ACT
Government

Territory Planning
Authority

Significant Development Stage 1 Information Package
DA-202544436 – Blocks 4 & 5 Section 7 PHILLIP

ATTACHMENT 1A – ENTITY ADVICE (STAGE 1 SIGNIFICANT DEVELOPMENT)

Image 1

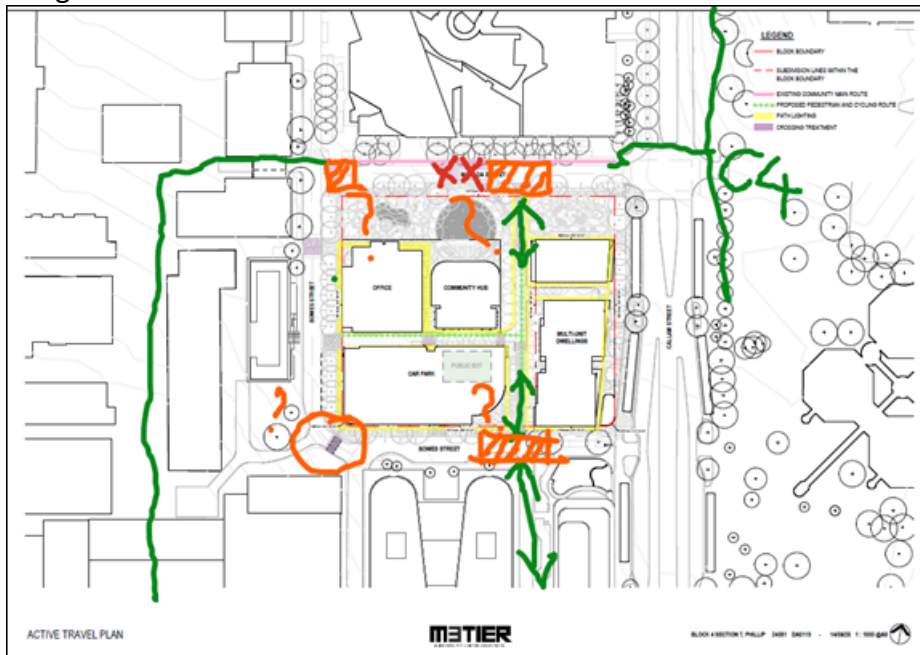
7. They are proposing the pedestrian and cycling route (north south), however the links to the existing main community route to the north (Matilda St). This is an important link that connects to the principal route (C4). We suggest moving the 'crossing treatment to align with the lane of the active travel route
8. There is an opportunity to provide raised treatment on the eastern part of Matilda Street
9. The southern side of the proposed peds and cycling route also needs to connect to the existing passage on the eastern side of the 'Grand tower' where seems to be in conflict to the entry driveway to the complex. They need to provide a detail of separated crossing facility at this location.
10. They may also need to pay attention to the crossing facility on the southwest corner of the block with another raised crossing or some threshold treatment at this location.

Image 2

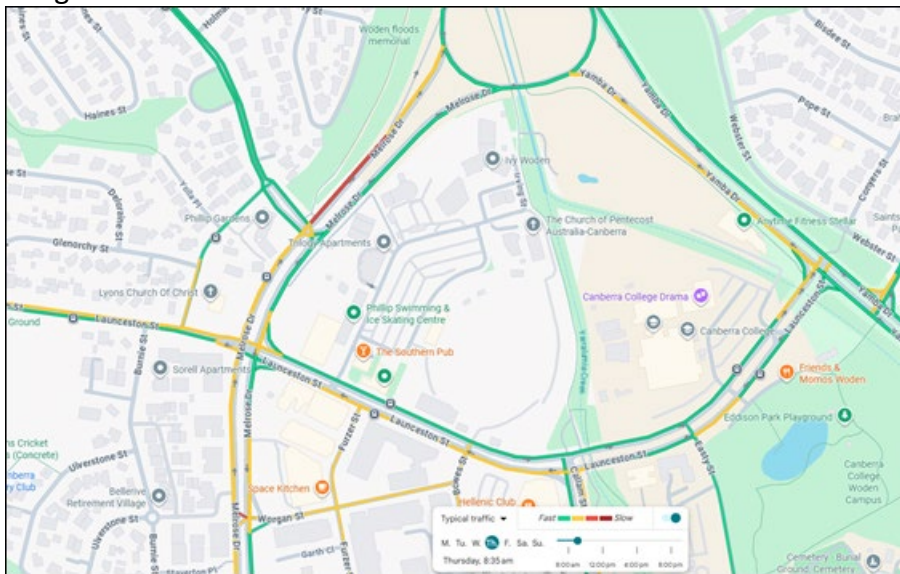
15. Section 2.6.2, pg. 25: It seems that the SIDRA 2025 base scenario has not been calibrated and validated to represent current traffic conditions. From the modelling results (Table 4), all intersections appear to be working well (i.e. LOS C or lower) without much congestion (i.e. DOS < 0.85). However, in reality, intersections along Launceston St, Melrose Dr, Easty St and Yamba Dr experience traffic operation issues especially in the peak hours, with longer delays, queueing and congestion, as shown in the screenshots below from Google Maps. Therefore, please calibrate/ validate the existing base models, and then use the calibrated and validated models for the future base and project case scenarios. If needed, it is advised to discuss with Roads ACT and seek the existing network

- performance (such as queuing, delays, etc), as they monitor this network through PTZ cameras and other ITS tools. As the future/ project case models were developed based on the non-calibrated/ validated models, it is anticipated that the network performance outputs are likely undermined. Therefore, CED are unable to accept these results, and subsequent study outputs and conclusions.
16. In addition, it seems that pedestrian crossings have not been coded at the signalised intersections and need to be coded. Refer to Active Travel comments as well.
 17. Section 2.6.2, pg. 25: Further to this, it is also noted that during initial discussions with Quantum Traffic in April 2025, it was agreed that traffic modelling analysis is to be undertaken using microsimulation modelling. Why has SIDRA intersection analysis been used instead?

Image 4

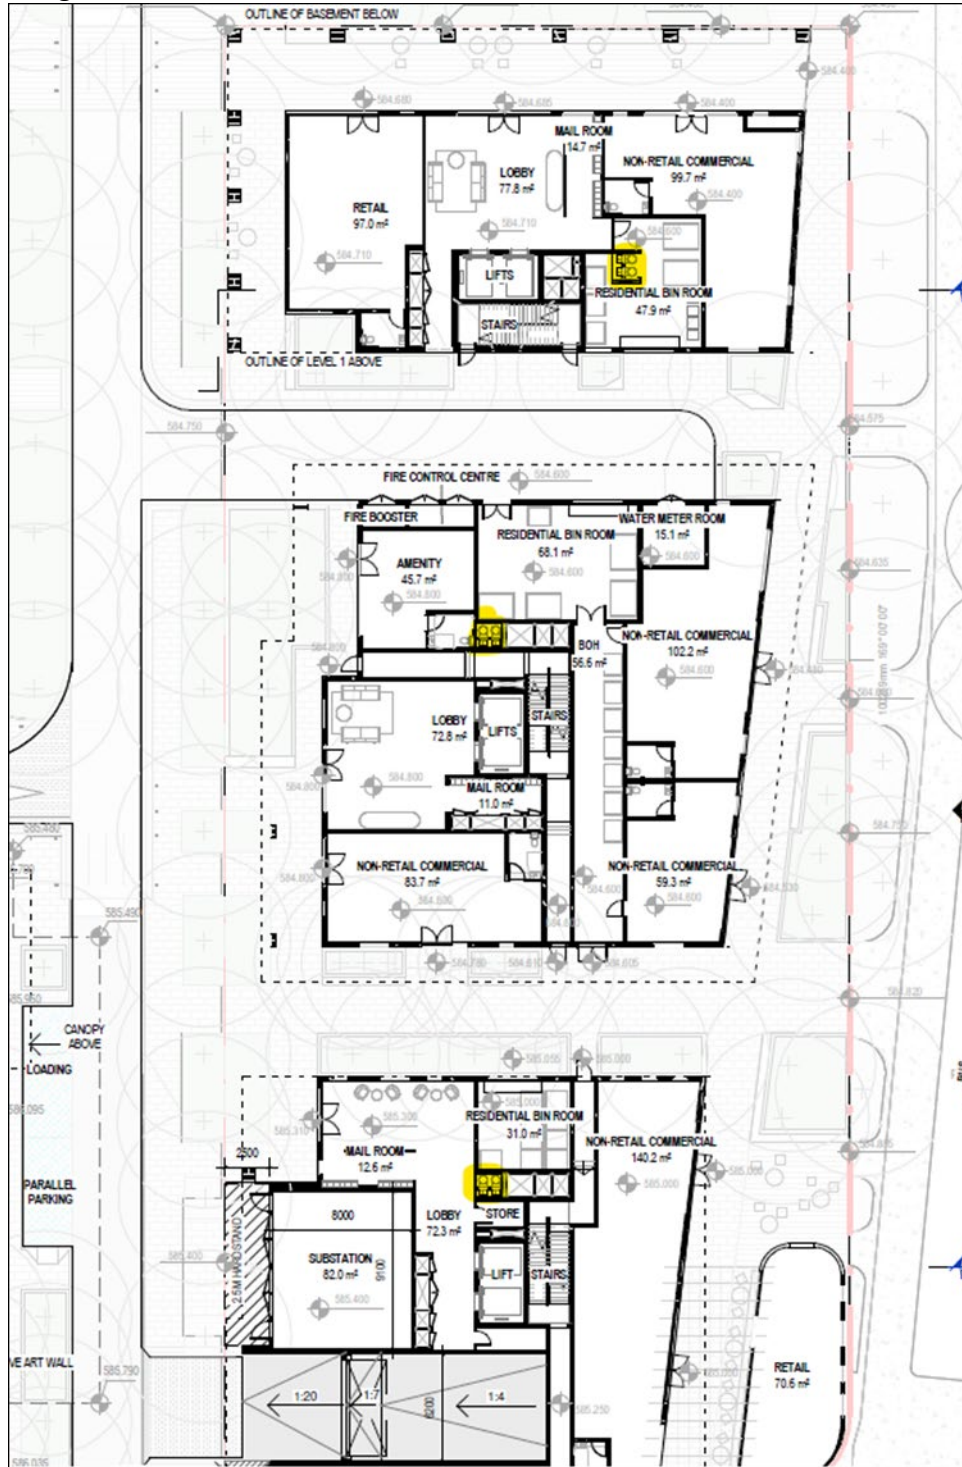
32. The residential building has 3 pairs of chutes, but the ground floor shows 1 x Residential Waste Enclosure and 2 x Waste Storage rooms (Image 4). Although the Operational Management Plan (OMP) state that the ground floor has chute rooms, the plans show waste storage rooms and an enclosure (Image 5) which cannot be used as chute rooms since the designs do not comply with the DCC and EAN24.

Image 5

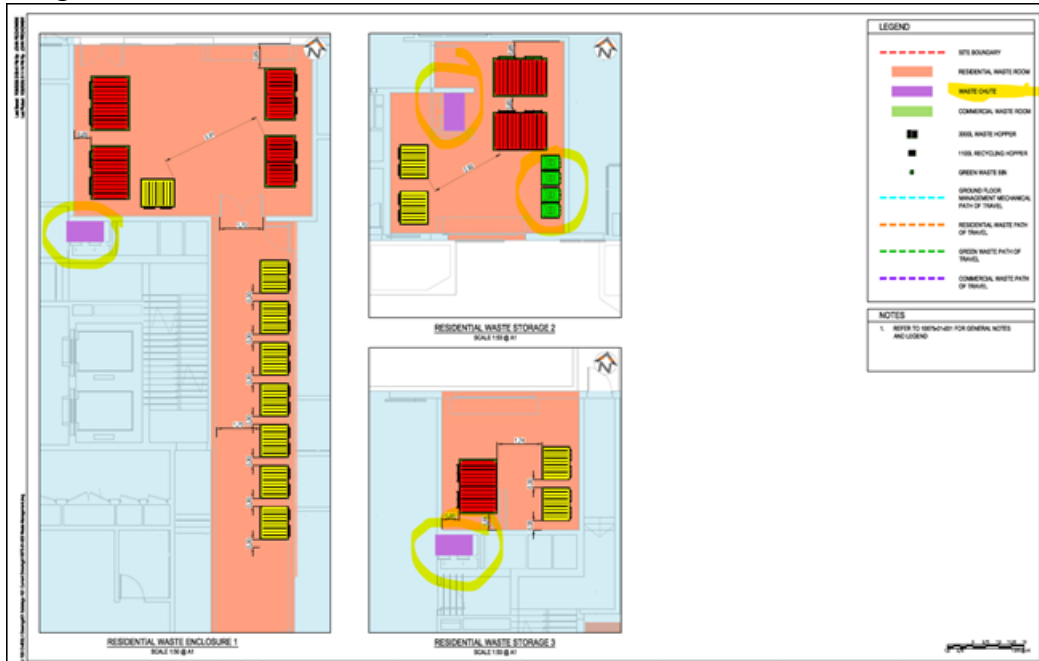
33. Chute Rooms are to be separate from the waste enclosure and access by residents is not permitted. The chutes and discharge points need to be located above the waste hopper and recycling hopper, and each chute room is required to provide spare hoppers (Image 5).

37. Green MGB's are to be stored in the waste enclosure as this are not permitted to be stored in chute rooms (ie Residential Waste Storage 2) (Image 5).

Image 6

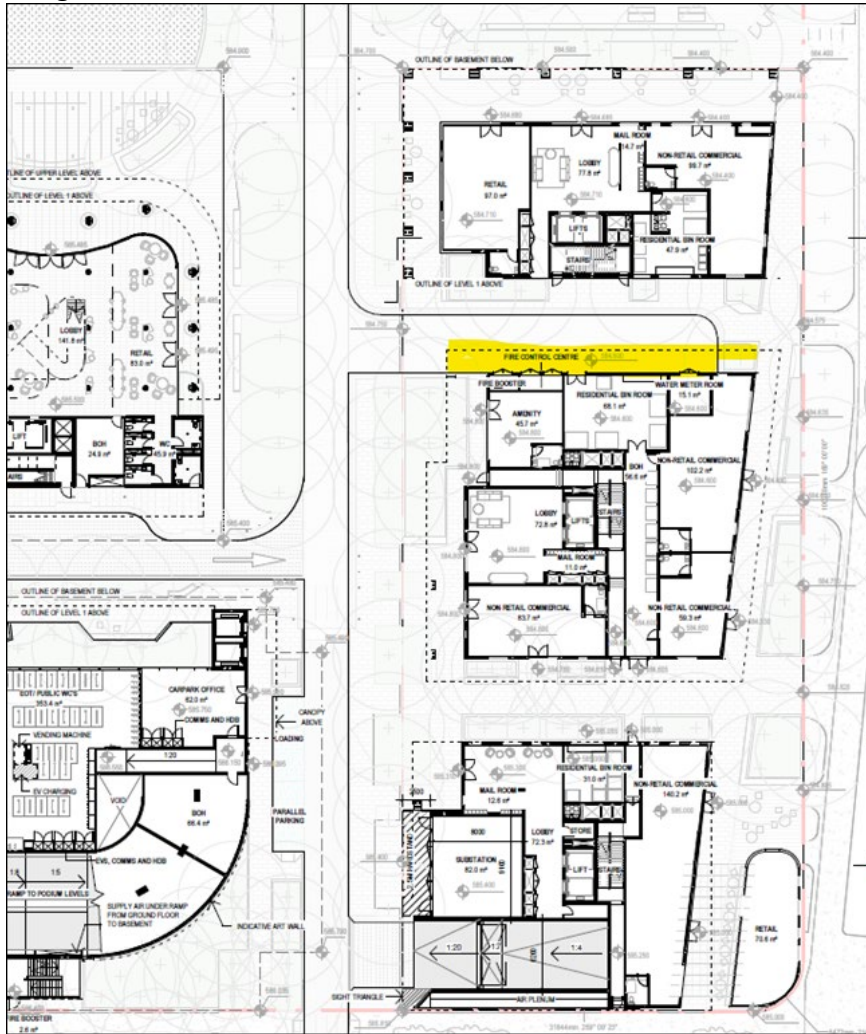
38. Vertical clearance for residential collection of 6.8m is required in the Service Laneway. Although Section E shows no obstructions on level 1 (Image 6), the ground floor plan shows an encroaching canopy (Image 7). Verification is required to confirm that 6.8m is provided in the laneway for waste collection.

Image 10

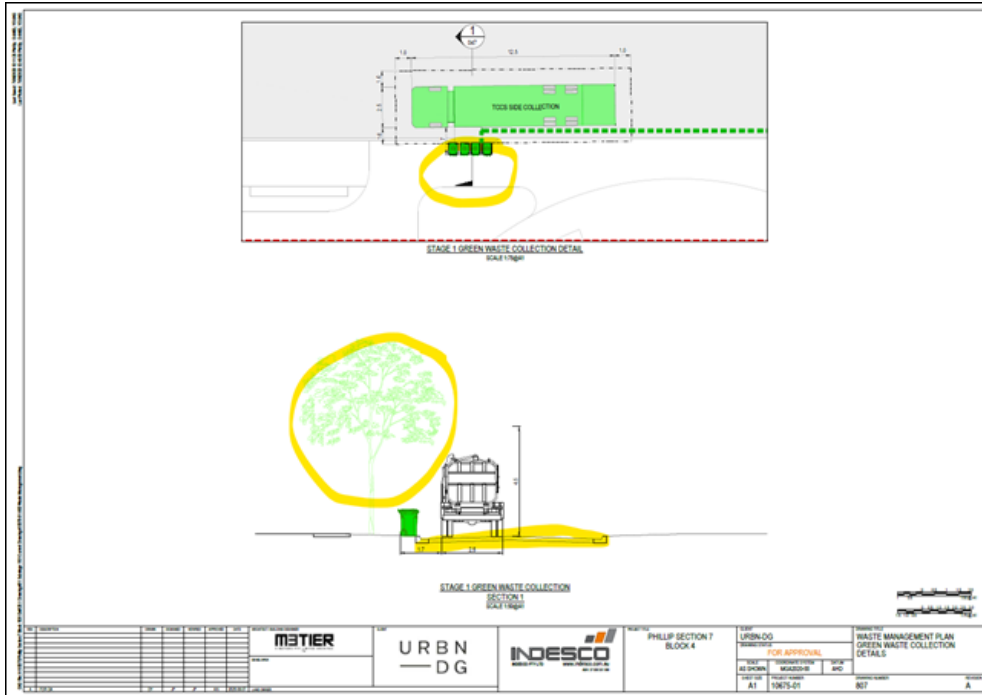
44. The quantitative carting distances are to be shown on the drawings and not just the path of carting (Image 12).
45. Carting distances exceeding 75m requires mechanical devices to assist the Building Manager to cart MGB/hoppers. If a mechanical device is to be used for carting, the plans are to show the storage location and specific details of the type of device is to be provided.

Image 13

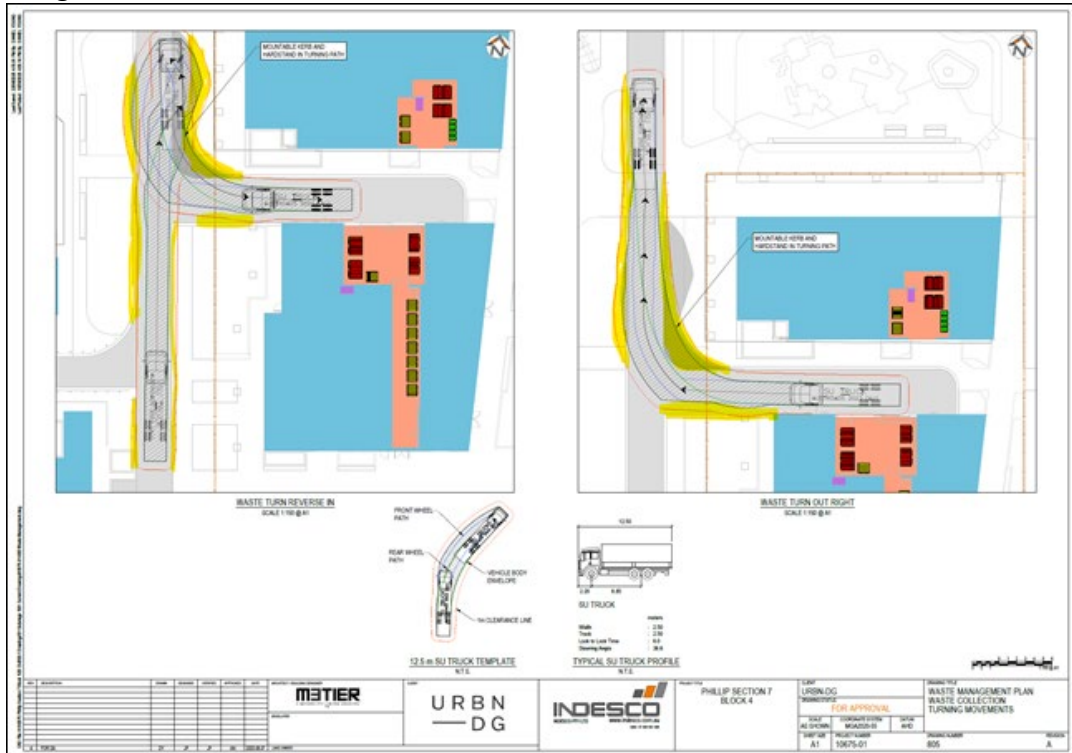
46. The collection vehicle must be able to safely navigate to and from the waste and recycling storage facility. The swept path simulation must demonstrate 1.0m minimum clearance between the collection vehicle's wheels and the kerb, even at pinch points, at all times. Swept vehicle software may not be accurate and does not account for driver error. To compensate for inaccuracies and driver error, the distances between wheels and kerb when navigating bends must show a minimum of 1.0m by using a vehicle length of 12.5m.

48. The waste collection vehicle movement drawing by INDESCO is required to show the entire movement for the residential waste collection when the vehicle enters the site from Bowes Street, manoeuvres into the service laneway and exiting onto Matilda Street (Image 14).

Image 14

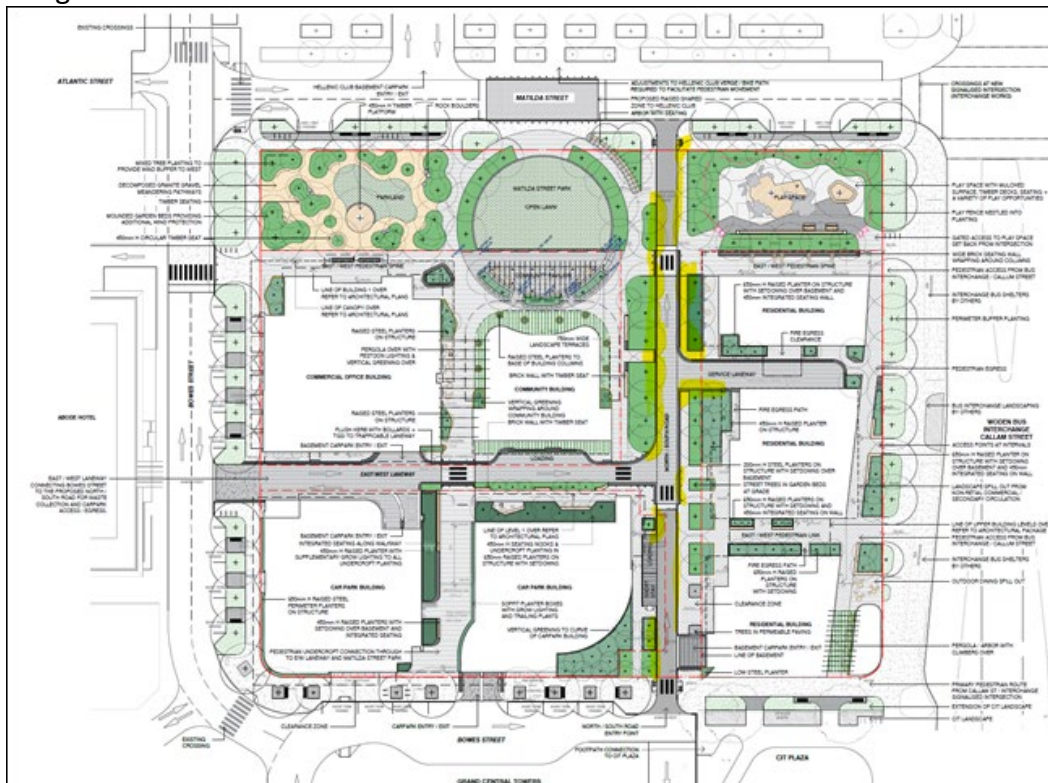
52. There are tree canopies and other obstacles located along the East/West Lane and North/South Road that encroach into the commercial waste collection vehicle movements (Image 14 above).

Image 15

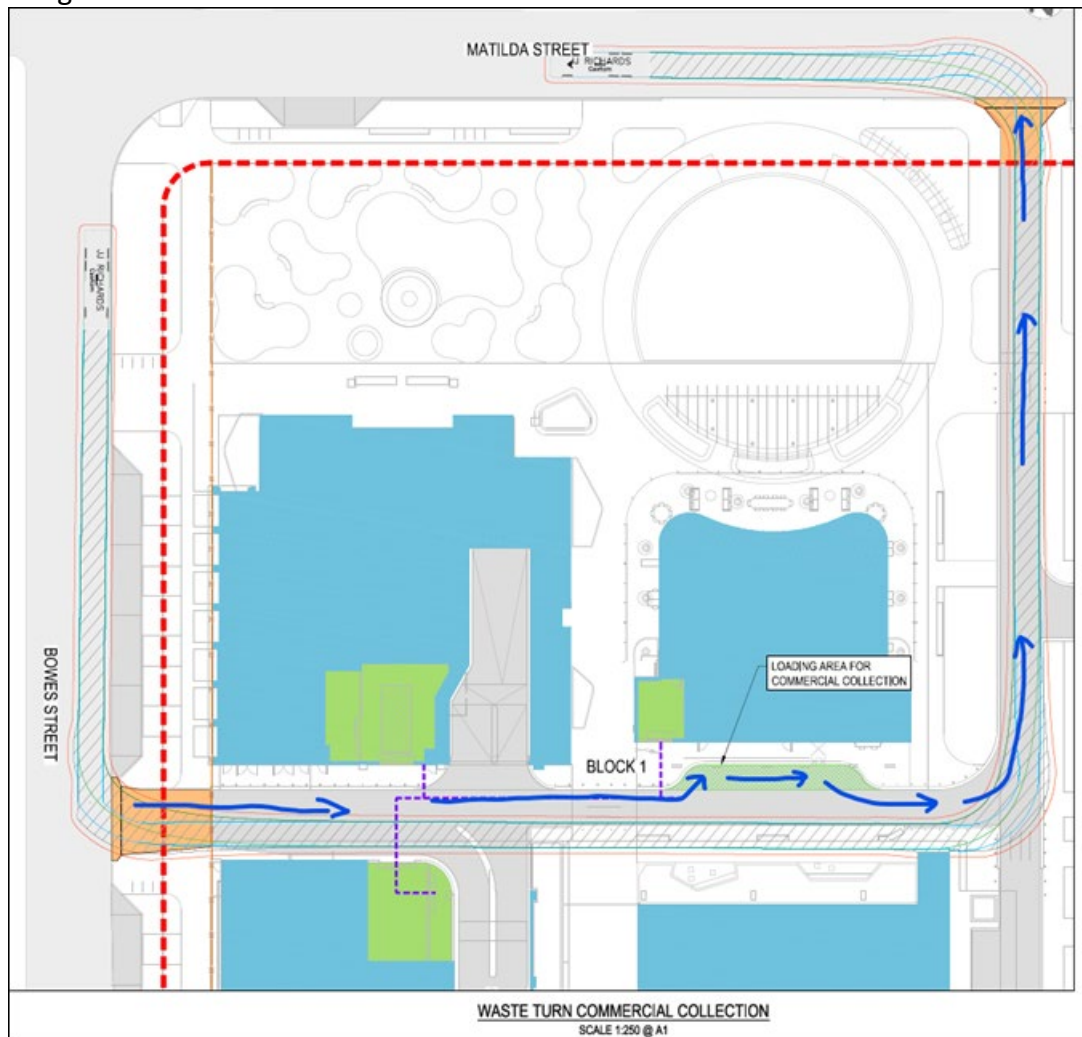
53. The commercial vehicle movement is required to show the vehicle entering the site from Bowes Street, onto the East/West Lane, enter the loading area for commercial collection, then continue towards the North/South Lane and exit onto Matilda Street (Image 15).

Image 22

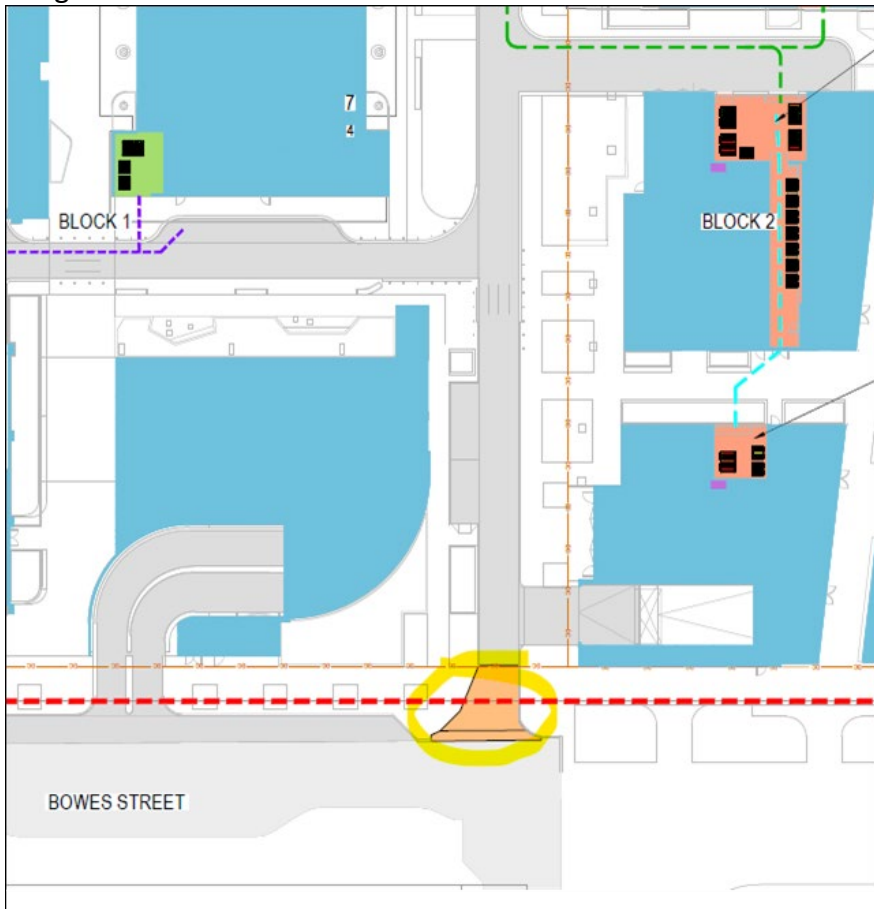
54. The verge crossings (Driveways 01 on Matilda Street, 02 and 03 on Bowes Street) do not have adequate dimensions since the turning path diagrams shows the vehicle movement encroaching outside of the driveway areas (Images 18, 19 & 20).
55. The vehicle movement templates for driveway 02 have not been provided (Image 21).
56. Driveway 02 along the southern part of Bowes Street shows driveway layout design that is shown inconsistent in the Driveway Plan, Landscape Plan, Waste Management Plans, Site Plan and Ground Floor Plans (Images 22 & 23).

Image 24

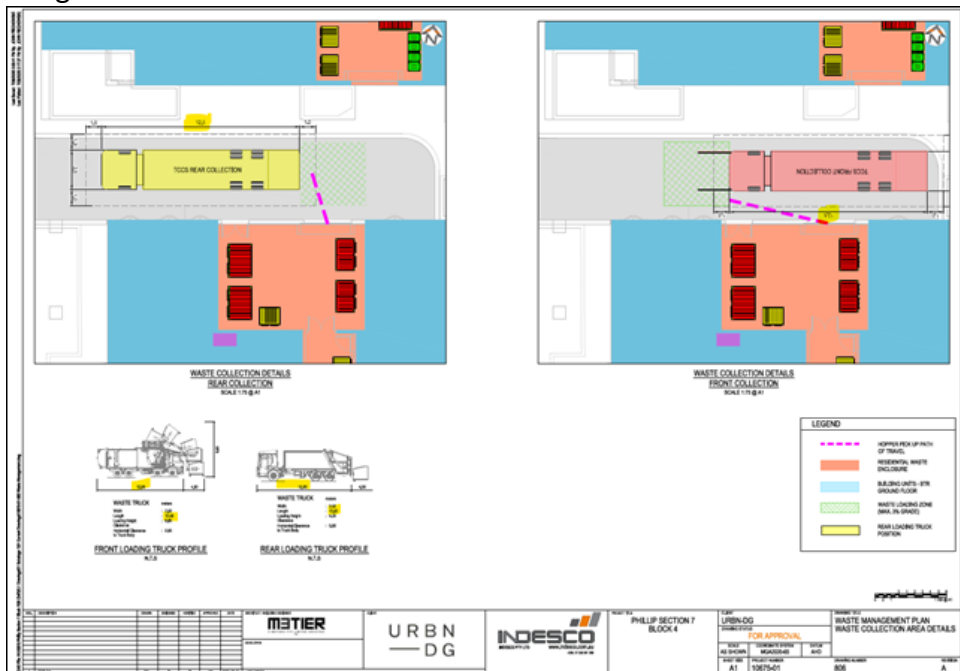
57. As shown in Image 24 below, the roll-out distance is diagonal and not dimensioned. The applicant must demonstrate a roll-out path from the waste enclosure to the hopper pad that does not exceed 4 metres. Additionally, the roller door of the waste enclosure currently restricts proper manoeuvring of the hoppers to the hopper pad.
58. The applicant must update the drawings to clearly demonstrate a safe manoeuvre path for the hoppers in front of the roller door, ensuring the distance does not exceed 4 metres.
